I write at the request of the Save Port Isaac Bay Group (SPIBG), who represent a number of concerned residents within the community of North Cornwall, in relation to a marine licence approved under MLA/2022/00180. The licence is for a 100 ha seaweed farm, west of Tregardock beach in Port Isaac Bay, in approximately 20 to 25 m of water. The developers are Penmayn Ltd., Falmouth, Cornwall.

The SPIBG has asked me to evaluate the existing information provided in the application documents relating to wave data and sea state, and to further evaluate data from other sites, in order to provide an assessment of the likely conditions at the application site.

Figure 1: Locations of the Port Isaac wave gauge and the Perranporth buoy, relative to the proposed seaweed farm site.

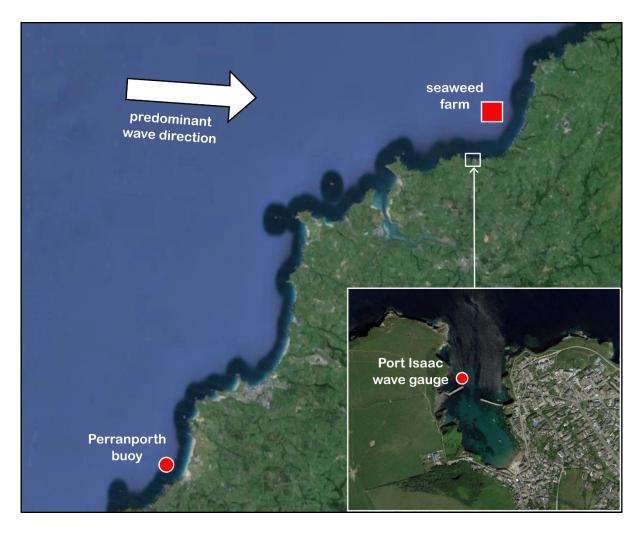
The geographical position from where these data were obtained is not representative of the proposed site. The wave gauge, at the western side of Port Isaac Harbour, is in a considerably more sheltered position and would experience wave heights much lower than those at the proposed site (Figure 1).

The nearest available historic data with a similar exposure to the proposed site are from the buoy-mounted sensor at Perranporth. Statistical summaries of the wave data from this buoy are available from the National Network of Regional Coastal Monitoring Programmes (Table 1, source: coastalmonitoring.org).

It is my recommendation that Cefas and the Environment Agency be consulted in relation to this licence and the data provided in the application, to ask whether they agree that the data upon which the licence was granted is representative of conditions at the proposed seaweed farm site.
